**PLANNED UNIT DEVELOPMENT  
& SUBDIVISION STAFF REPORT****Date: March 15, 2012**

**DEVELOPMENT NAME** Hillwood Plaza Subdivision, Re-subdivision of Lots 1 & 3B

**LOCATION** 2370 Hillcrest Road  
(Northwest corner of Hillcrest Road and Cottage Hill Road)

**CONTEMPLATED USE** Planned Unit Development approval to modify an approved PUD to allow multiple buildings on single building site and to allow shared access and parking between four building sites, and Subdivision approval to create two legal lots from one existing legal lot of record.

SITE PLAN

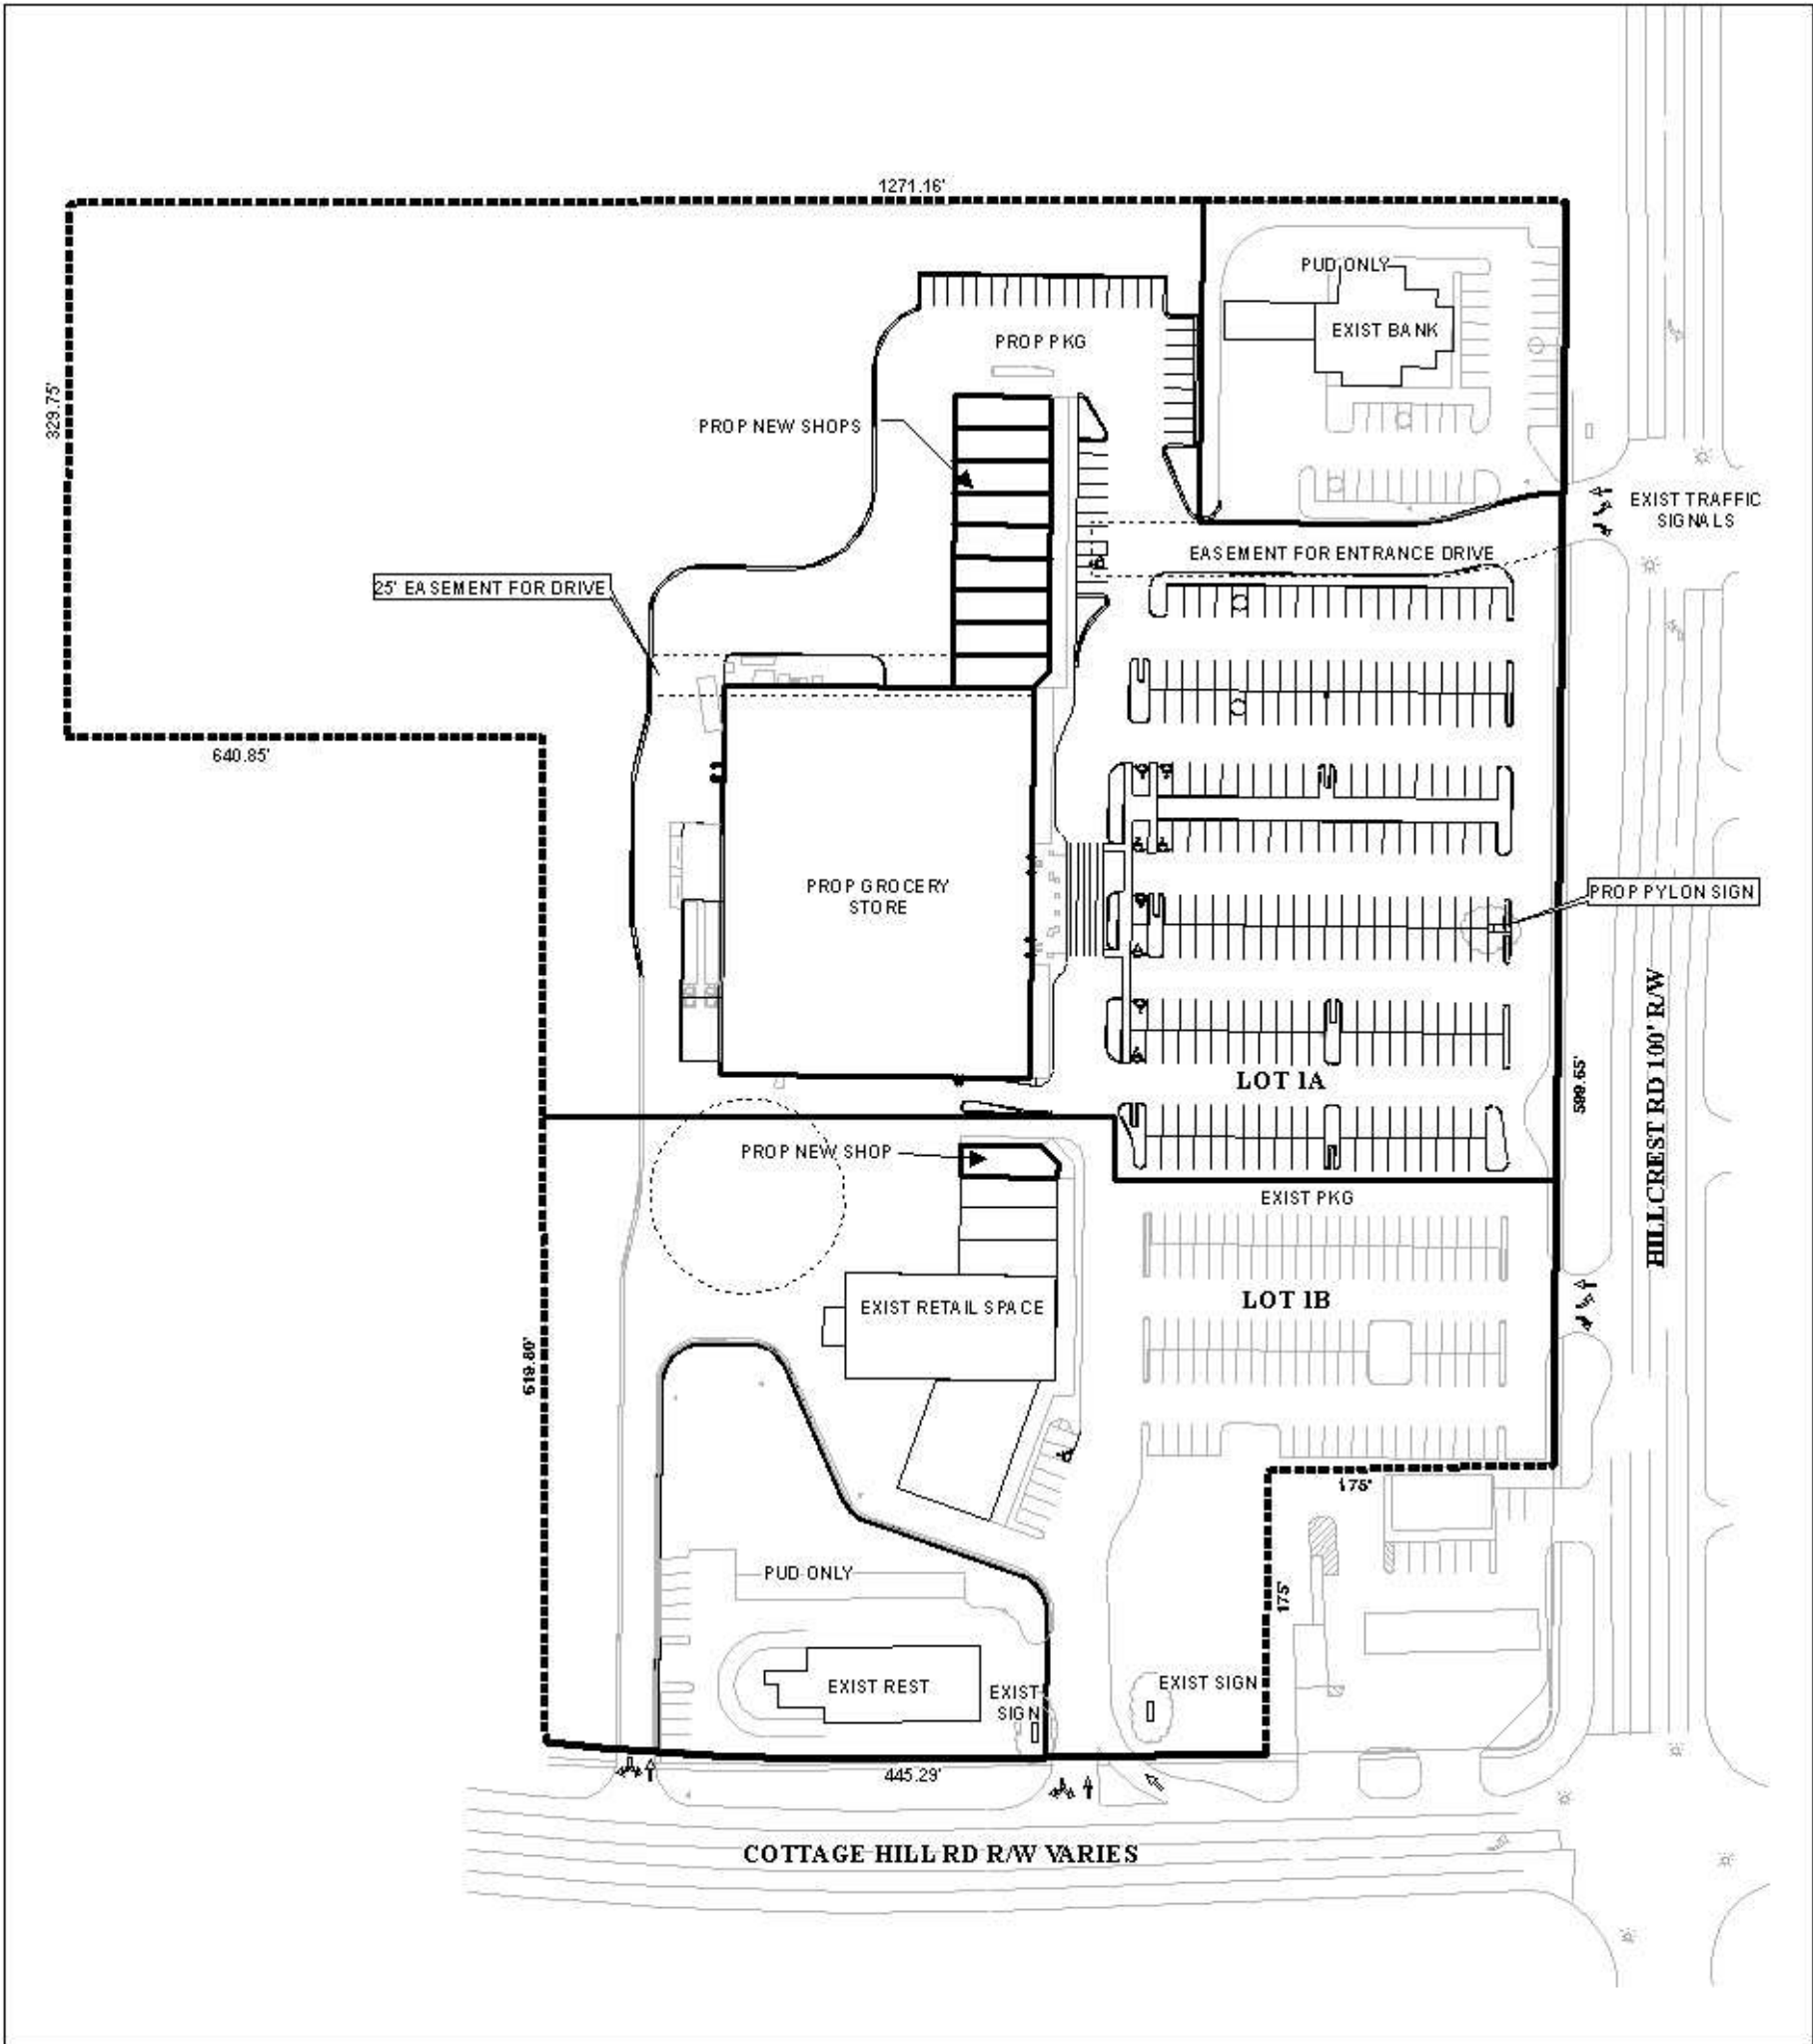
The applicant has submitted a site plan illustrating the placement of the building, parking, dumpster location, and landscaping and tree plantings. The development illustrates 388 parking spaces, whereas the proposed development requires 250 spaces for retail services, the developer envisions to provide tenant spaces to food service tenant; therefore, planning to provide the parking spaces to meet the requirements of the parking ratio food services.

The site is adjacent to R-3, Multi-Family Residential uses to the; therefore, would be required to comply with the buffer requirements of the Ordinance. Lighting of the parking area and site must comply with Sections 64-4.A.2 and 64-6.A.3.C of the Zoning Ordinance.

- 1) the submission of two copies of the revised Planned Unit Development site plans prior to the signing of the Final Plat;
- 2) placement of a note on the Planned Unit Development site plan stating the development is limited to the existing curb cuts to Hillcrest Road and Cottage Hill Road to include the modifications suggested by Traffic Engineering (*The southern driveway on Hillcrest Road should be modified to a right-in, right-out only, with a raised island. Traffic striping for the northern driveway approaching the traffic signal at Hillcrest Road should be improved to delineate one inbound lane and two outbound lanes for approximately 150'. Traffic striping for the eastern driveway approaching Cottage Hill Road should be improved to delineate one inbound lane and one outbound lane for approximately 50'. Traffic striping includes thermoplastic lane lines, stop bars and arrow legends*) and conform to AASHTO standards;

- 3) placement of a note on the Planned Unit Development site plan stating the development will comply with Engineering comments (*Any existing sidewalk panels and/or driveway curb cuts damaged along Cottage Hill Road or Hillcrest Blvd. will need to be replaced. A C.O.M. ROW permit will be required before any work is done within the ROW. Any proposed revisions to any existing drainage easements will need to coordinate with the Engineering Department. According to the City of Mobile's 1984 Aerial photographs, there is some impervious area that can be claimed as historical credit for the determination of the need for detention. The engineer will need to quantify the amount of historical credit requested and any existing detention facilities. A complete set of construction plans and drainage calculations for any proposed site work (including drainage, utilities, grading, stormwater systems, paving) will be required to be submitted with the Land Disturbance permit. These plans are to be submitted and approved prior to beginning any of the construction work. Existing utility lines located underneath the proposed building will need to be relocated. Any work performed in the existing ROW (right-of-way) will require a ROW permit from the City of Mobile Engineering Department (208-6070) and must comply with all City of Mobile ROW code and ordinances.*);

- 4) placement of a note on the Planned Unit Development site plan stating that all projects within the City of Mobile Fire Jurisdiction must comply with the requirements of the 2009 International Fire Code, as adopted by the City of Mobile;
